MEMO

To: Kristopher Byrd, Well Construction and Compliance Section Manager
From: Travis Kelly, Well Construction Compliance Coordinator
Subject: Review of Water Right Application G-19153
Date: February 4, 2022

Application # G- 19153

D. WELL CONSTRUCTION, OAR 690-200

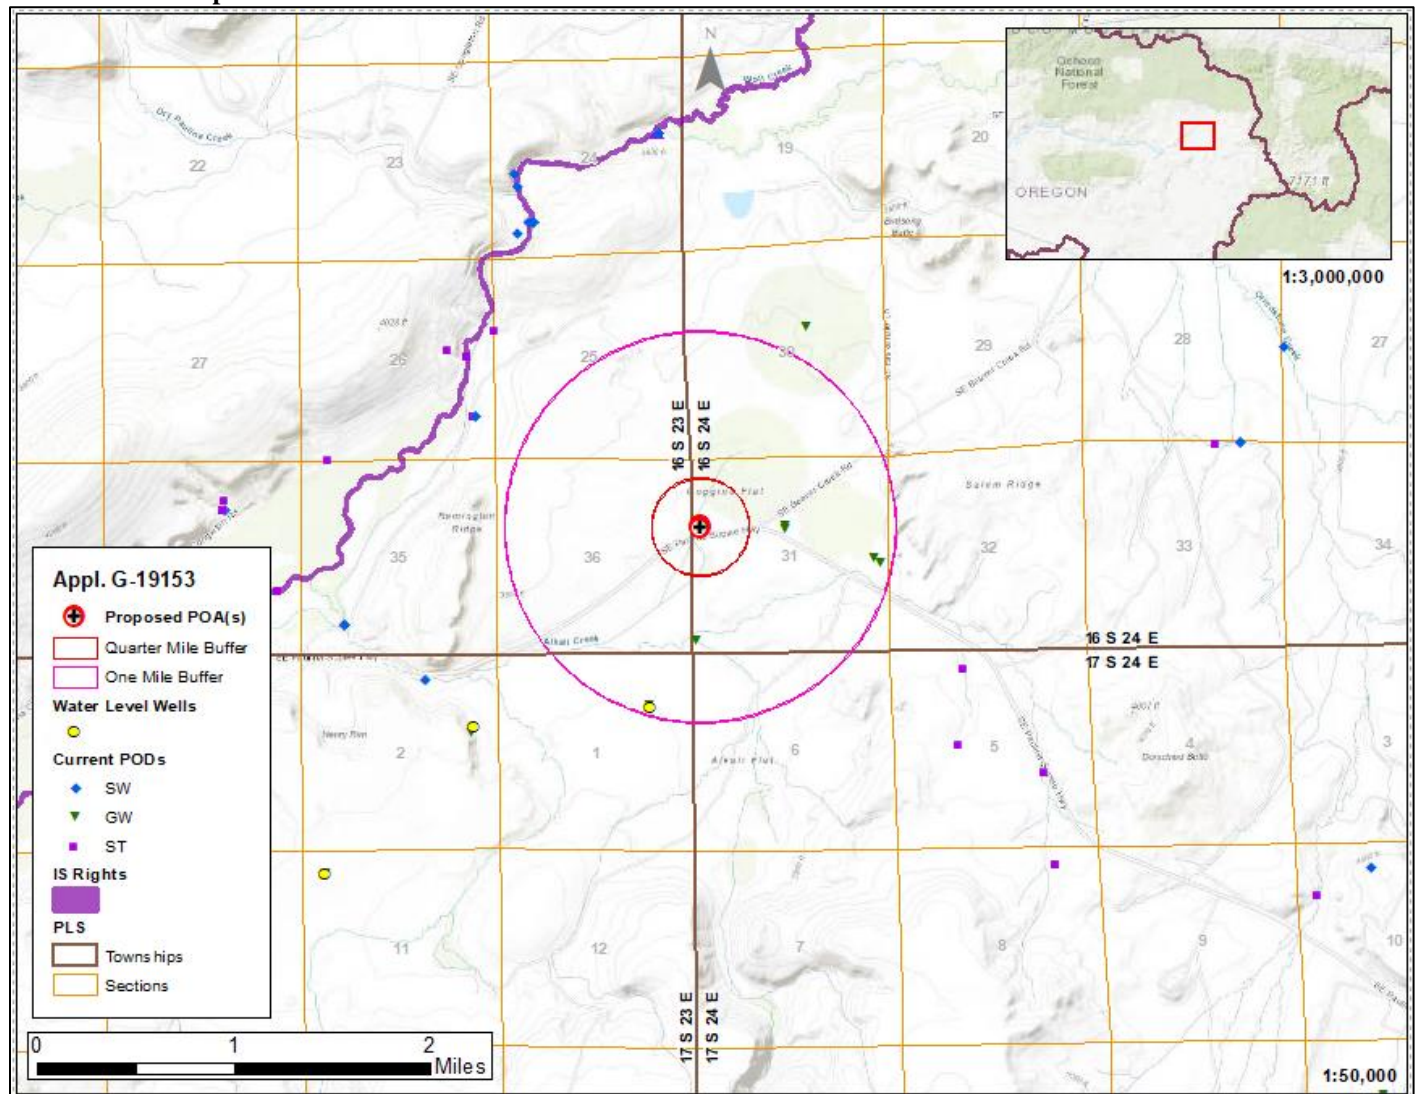
D2. **THE WELL does not appear to meet current well construction standards based upon:**

- a. review of the well log;
- b. field inspection by _____;
- c. report of CWRE _____;
- d. other: (specify) _____

D3. **THE WELL construction deficiency or other comment is described as follows:** _____

D4. **Route to the Well Construction and Compliance Section for a review of existing well construction.**
